HISTORIC PRESERVATION BOARD

HISTORIC PRESERVATION BOARD MEETING

**PUBLIC HEARING
35 COMMERCIAL STREET**

TO: Chair Pollard and Members of the Historic Preservation Board
FROM: Rob Wiener, Preservation Compliance Coordinator
DATE: December 29, 2020
RE: January 6, 2021 **Public Hearing** – Exterior Alterations and Additions

A2.01

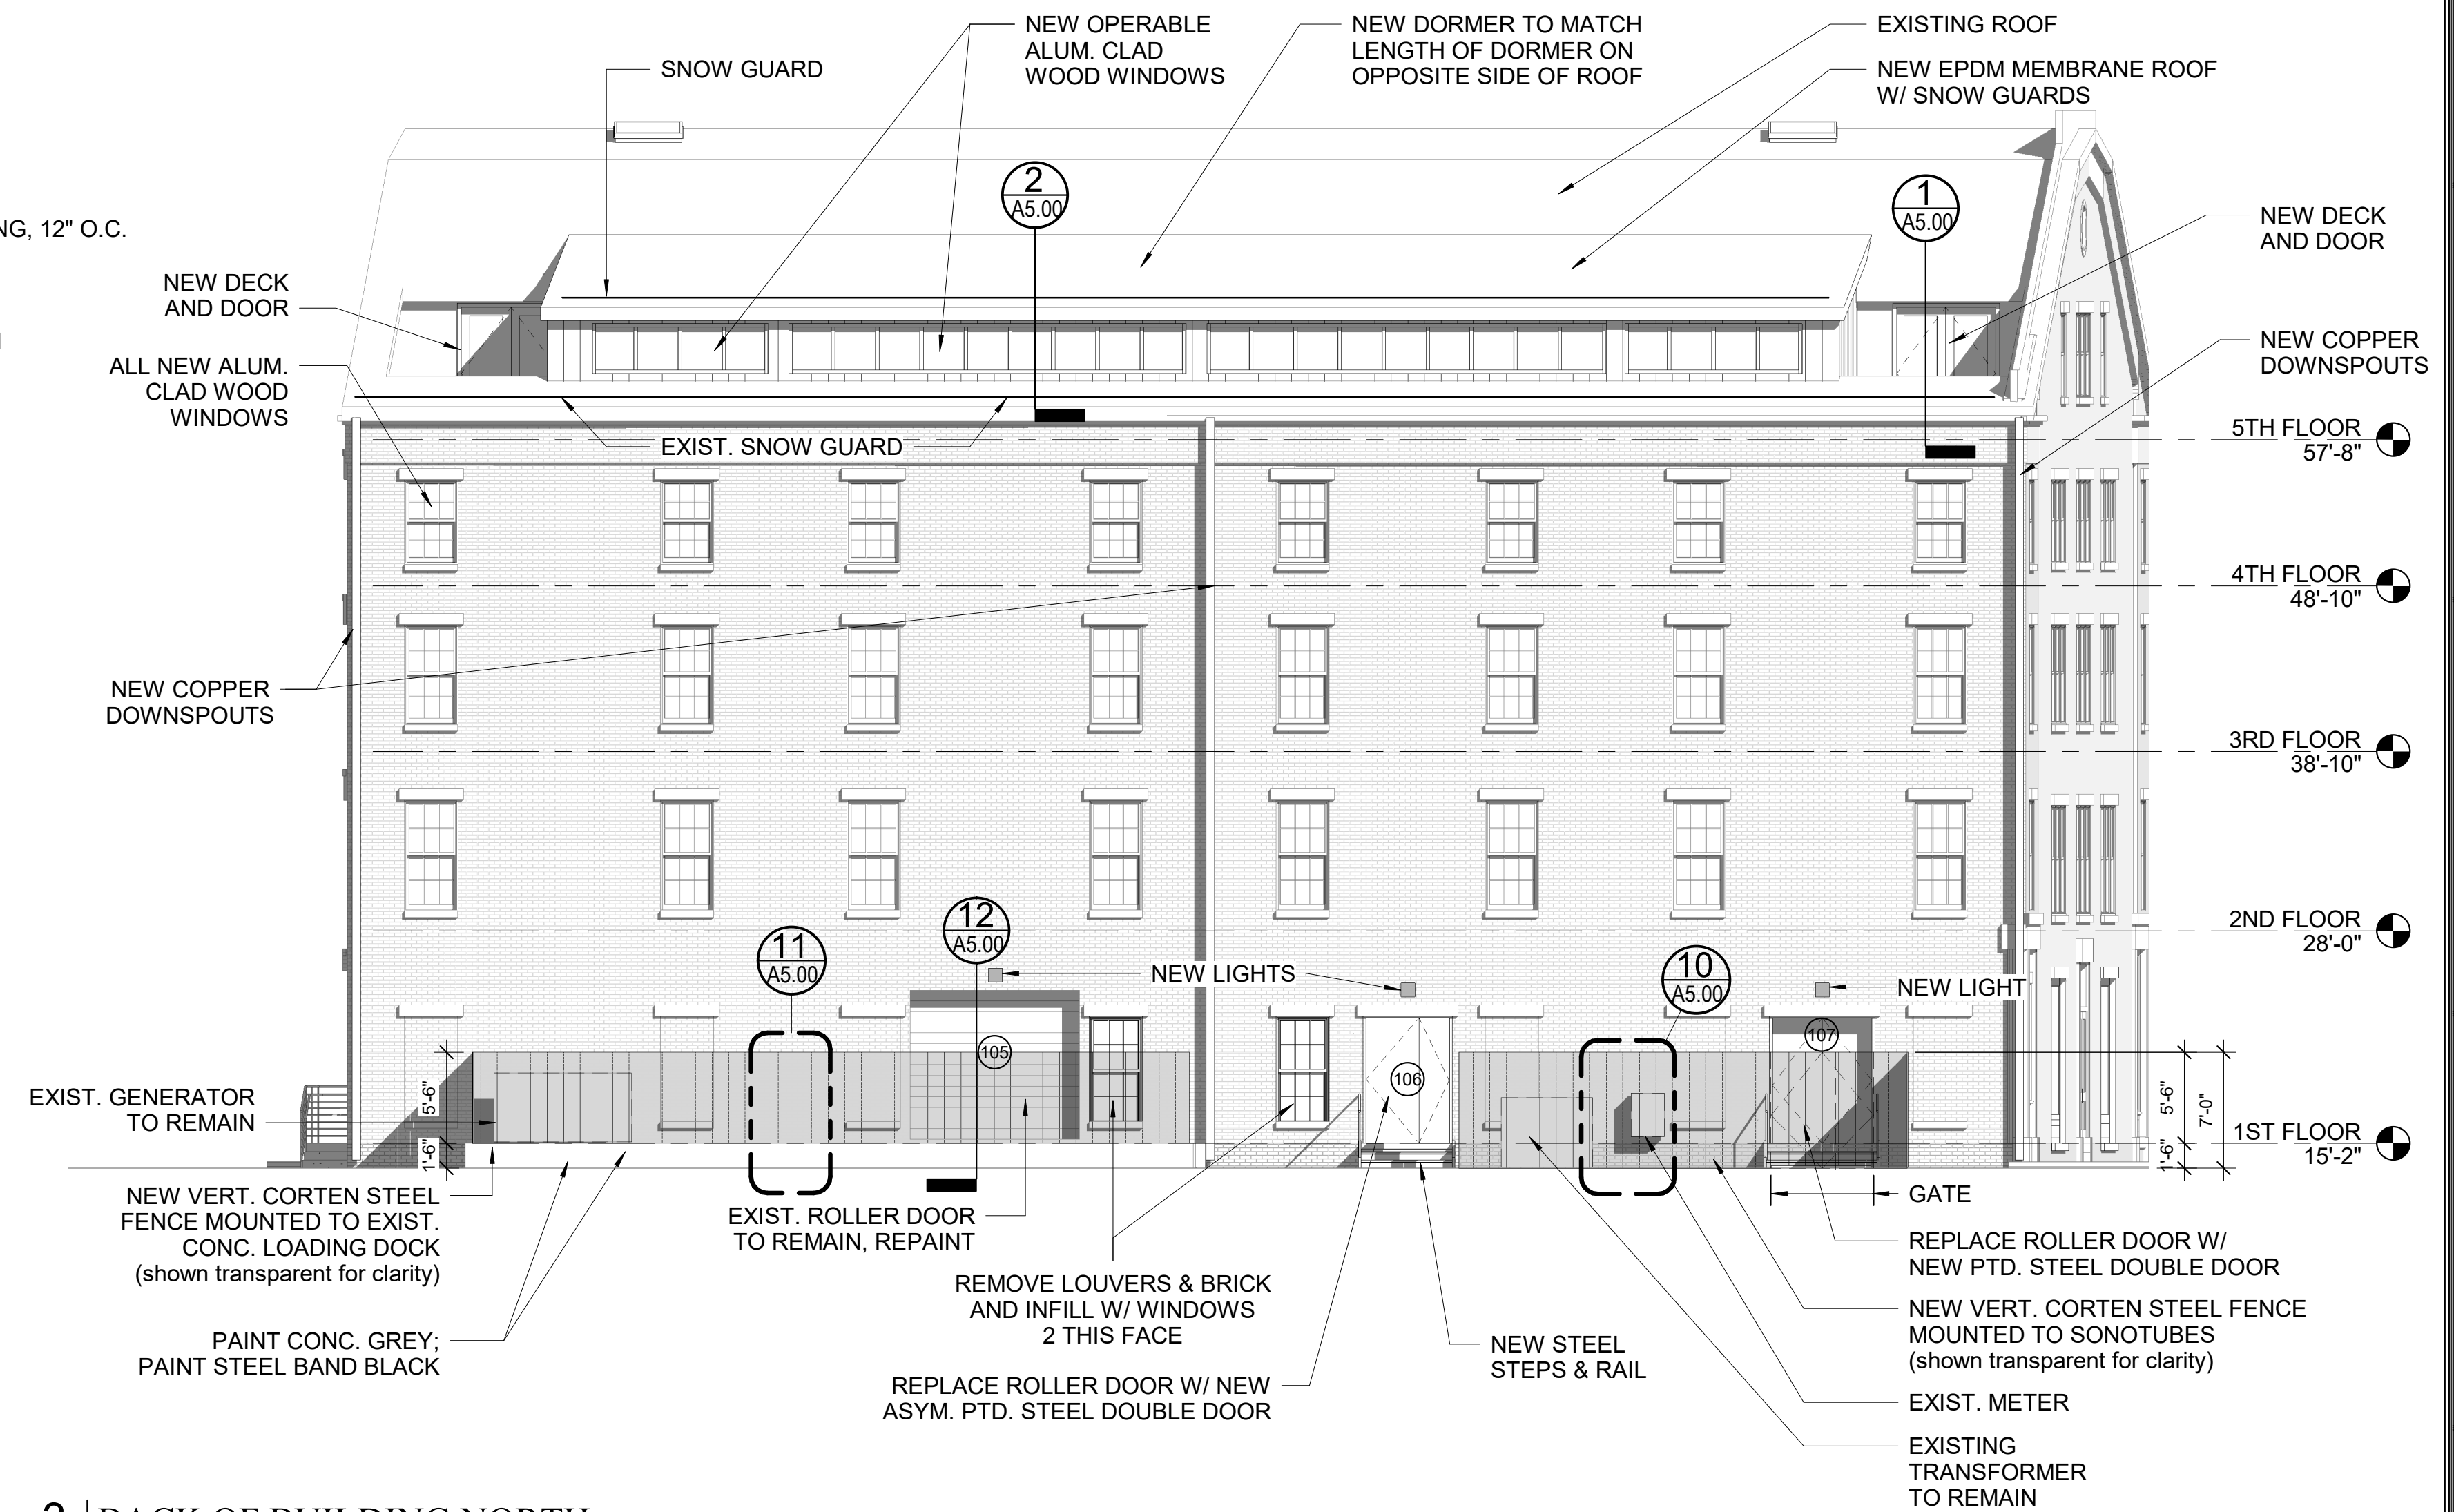
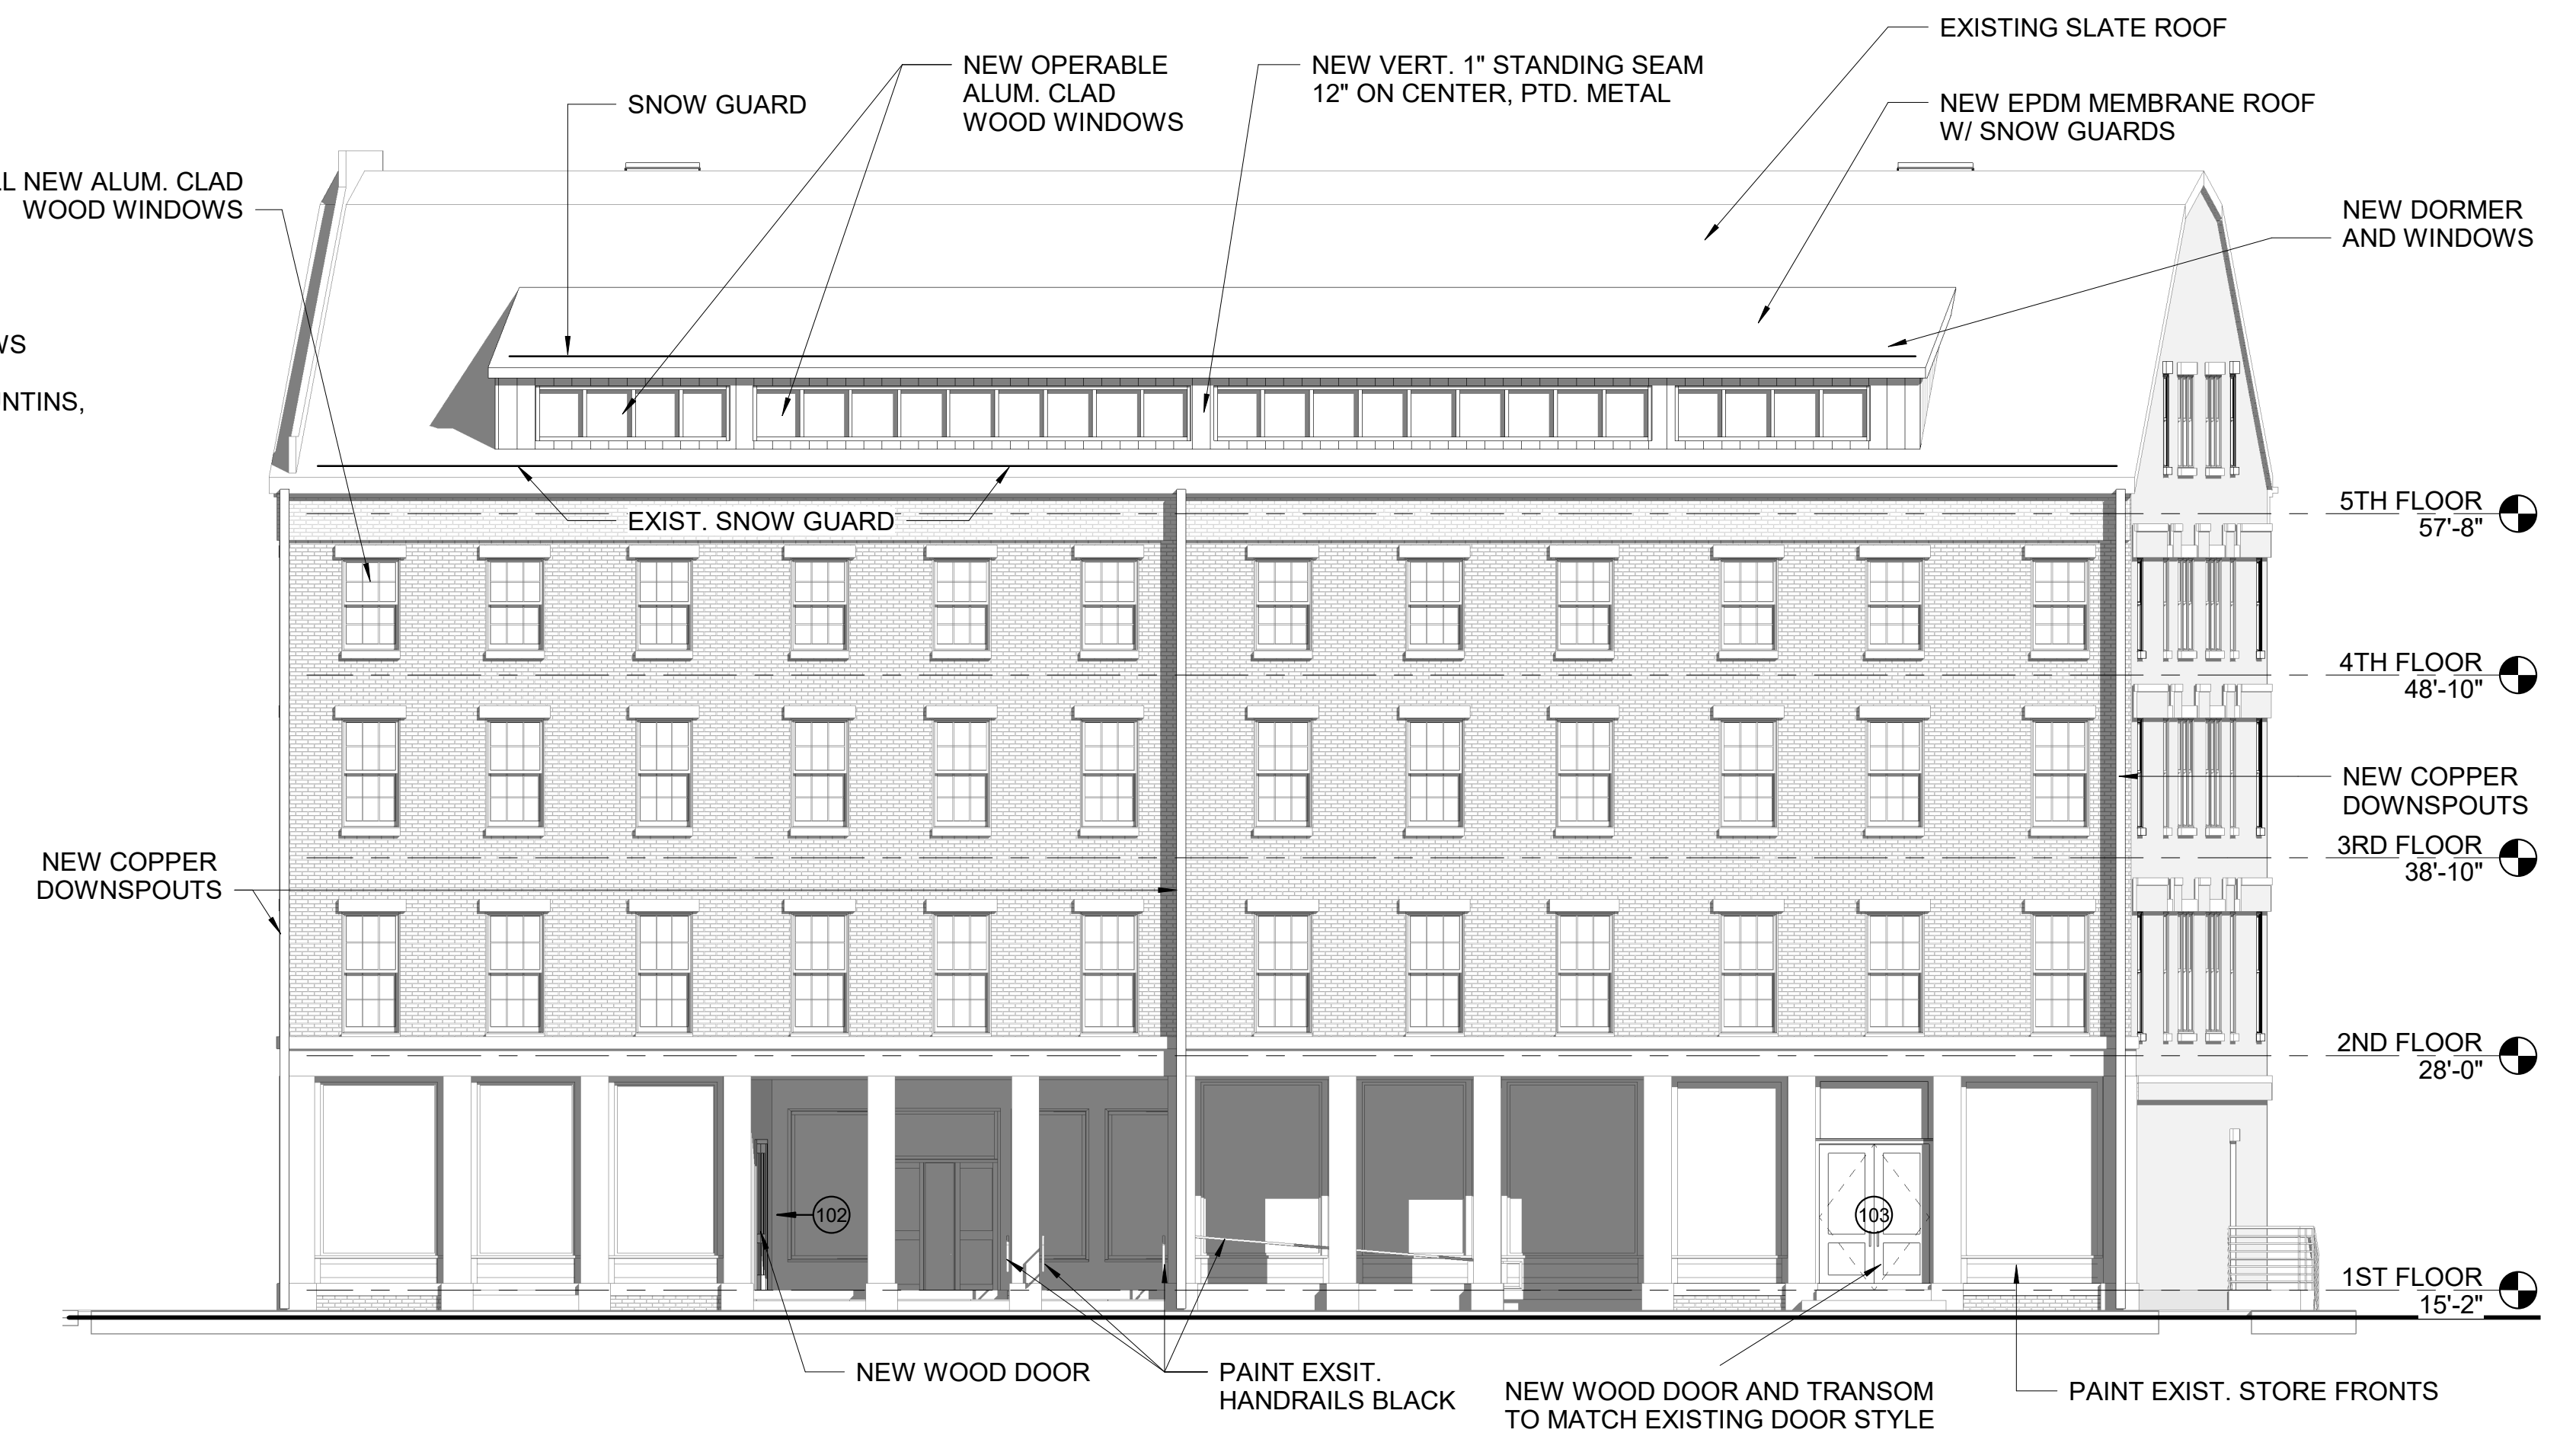
- Additional windows were proposed for the east and west ends as part of the December 2 presentation; this was a change from the version included with the packet. *Board response was to urge a reduction in the number of new windows, noting that the original warehouse character would be further weakened by overloading the once largely blank end walls with windows for residences.*

- Based on the Board's deliberations on December 2, there is support for the proposed matching, continuous dormers and a reduced number of new windows on the building ends.

1. East elevation, we have deleted 6 proposed windows on floors 2, 3 and 4.
2. East elevation we have eliminated the proposed storefront.
3. East elevation we have added two windows on 5th floor that match the floor below.

4. West elevation we have eliminated 4 proposed windows on 5th floor, so no changes to the window openings from 2nd – 5th floor this elevation.
5. West elevation the two new storefronts will be detailed to match storefront installation on South elevation, note the center vertical mullion is eliminated.

6. West elevation the existing wood doors are to be repaired and painted with two new light fixtures added on each side, see fixture below.
7. South elevation, new doors to match detailing of existing doors on west elevation.

8. North elevation, changes and dimensions in steel fence adjusted.
9. North elevation light fixtures, see below, added over doors and all doors specified.

10. North Elevation steel steps and railing shown.
11. Shed dormers to be a painted metal, color to be dark warm grey.
12. Replacement windows aluminum wrapped wood to be dark grey warm grey
